Accessibility Review Report – DA Review

Project Title: Waverly Council Chambers Upgrade
49A Bondi Road, Bondi Junction

Report Version: 20498_ADR_DA_v1.2

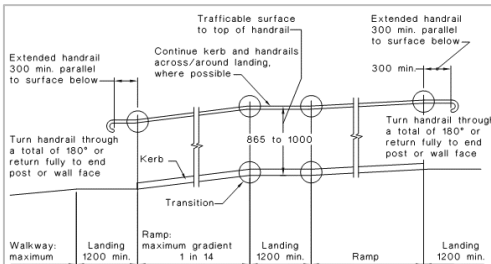
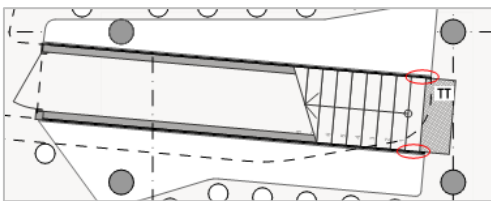
DtS Provision	Comment(s)/Recommendation(s)	Status
<p>Buildings and parts of the building must be accessible as required by Table D3.1, unless exempted by D3.4. Table D3.1 requires that access is provided –</p> <p><u>Class 5, 6, 7b, 8, 9a –</u></p> <ul style="list-style-type: none"> To and within all areas normally used by the occupants. 	<p>Access is generally proposed throughout the required new portions of the building as prescribed by Cl. D3.1 of the BCA.</p> <p>Note the “affected part” upgrades outlined in the Premises Standard will apply to this development. Any areas captured under the “affected part” provisions will need to comply with the latest BCA/AS provisions.</p> <p>Access to existing areas which do not form part of the new works and not captures under the Premises Standard are excluded from this report.</p> <p><u>Doorways</u></p> <p>All doorways along an accessway are required to have a clear door opening width no less than 850mm clear and be provided with door circulation spaces as prescribed by AS1428.1-2009.</p> <p><u>Compliance Departure(s) –</u></p> <p>The doorway leading into the BOH corridor on the Ground Floor (highlighted in red below) is not provided with the required 510mm and 530mm respective latch side circulation (note the approach from both sides of the doorway is non-compliant).</p> 	CD/DD

<p><u>Resolution(s) –</u></p> <p>Either –</p> <ul style="list-style-type: none"> • Provide the prescribed door circulation space in each instance in accordance with Figure 31 of AS1428.1-2009; or • Where a compliant scenario cannot be achieved it may be possible to pursue a Performance Solution to justify the reduction of some of the door circulation space compliance departures raised above. This is to be determined on a case-by-case basis and will require further design development/discussion. <p>Subject to the above, compliance is readily achievable with minor design development and/or specification at the Detailed Design Stage.</p>	
--	--	--

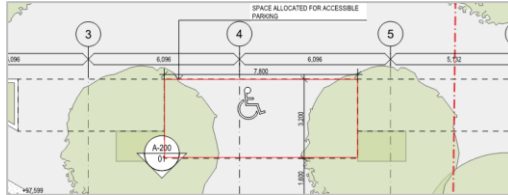
DtS Provision	Comment(s)/Recommendation(s)	Status
In a building required to be accessible every ramp and stairway, except for ramps and stairways in areas exempted by D3.4, must comply with –		
<ul style="list-style-type: none"> for a ramp, except a fire-isolated ramp, clause 10 of AS 1428.1; and 	<p>All non-fire-isolated ramps are required to comply with AS1428.1-2009.</p> <p>Compliance is readily achievable with minor design development and/or specification at the Detailed Design Stage.</p> <p>Extract from AS1428.1-2009 is provided below for reference:</p> 	DD
<ul style="list-style-type: none"> for a stairway, except a fire-isolated stairway, clause 11 of AS 1428.1; and 	<p>All non-fire-isolated stairways are required to comply with AS1428.1-2009.</p> <p>It is noted that the new fire isolated stairway is proposed to be used as an open/communication stairway. As a result, the stairway will need to fully comply with AS1428.1-2009.</p> <p>The new communication stairway is required to be provided with the one-tread + 300mm horizontal handrail extensions at the bottom landing – refer to markup below:</p> 	DD

<p>Compliance is readily achievable with minor design development and/or specification at the Detailed Design Stage.</p> <p>Extract from AS1428.1-2009 is provided below for reference:</p> 	
<ul style="list-style-type: none"> for a fire-isolated stairway, clause 11.1(f) and (g) of AS 1428.1; and 	<p>Compliance is readily achievable with minor design development and/or specification at the Detailed Design Stage.</p>	DD
<p>Accessways must have—</p> <ul style="list-style-type: none"> passing spaces complying with AS 1428.1 at maximum 20 m intervals where a direct line of sight is not available turning spaces complying with AS 1428.1 at 20m intervals or within 2m of the termination of an accessway. 	<p><u>Compliance Departure(s) –</u></p> <p>The provision of a 180 degree turning bay is not provided with 2m of the end of the accessway on Level 3 (adjacent to meeting room – refer to markup below). Note doorway to the terrace is existing, but should still be provided with compliant doorway circulation as prescribed in AS1428.1-2009.</p>  <p><u>Resolution(s) –</u></p> <ul style="list-style-type: none"> Provide the prescribed 1540mm x 2070mm circulation space within 2m of the end of the accessway. Ensure compliant circulation is provided to the existing terrace doorway. <p>Subject to the above, compliance is readily achievable with minor design development and/or specification at the Detailed Design Stage.</p>	CD/DD

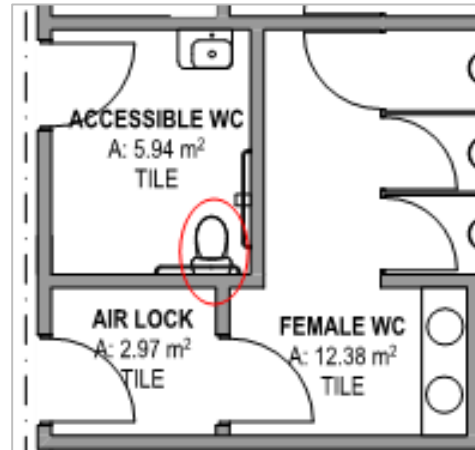
DtS Provision	Comment(s)/Recommendation(s)	Status
<p>In a building required to be accessible:</p> <ul style="list-style-type: none"> • Accessible unisex sanitary compartments must be provided as in accordance with Table F2.4(a), • Accessible unisex showers must be provided in accordance with Table F2.4(b), • At each bank of toilets where there is one or more toilets in addition to an accessible unisex sanitary compartment at that bank of toilets, a sanitary compartment suitable for a person with an ambulant disability in accordance with AS 1428.1 must be provided for use by males and females. • An accessible unisex sanitary compartment must contain a closet pan, washbasin, shelf or bench top and adequate disposal of sanitary towels. 	<p><u>Accessible sanitary compartments –</u></p> <p>New accessible unisex sanitary compartments are proposed as follows:</p> <ul style="list-style-type: none"> • 2 x new accessible unisex sanitary compartments on the ground floor. • 1 x new accessible unisex sanitary compartment on Level 1. • 1 x new accessible unisex sanitary compartment on Level 2. • 1 x new accessible unisex sanitary compartment on Level 3. <p>The facilities proposed are spatially readily capable of complying with AS1428.1-2009. Further details to be provided during the design development stage.</p>	CD/DD

Left and right hand closet pan transfers are not provided as evenly as possible –

- 1x LH (Ground Floor)
- 4x RH (Ground Floor, Level 1, 2 and 3)

Ensure LH and RH transfer accessible sanitary compartments are provided as evenly as possible.
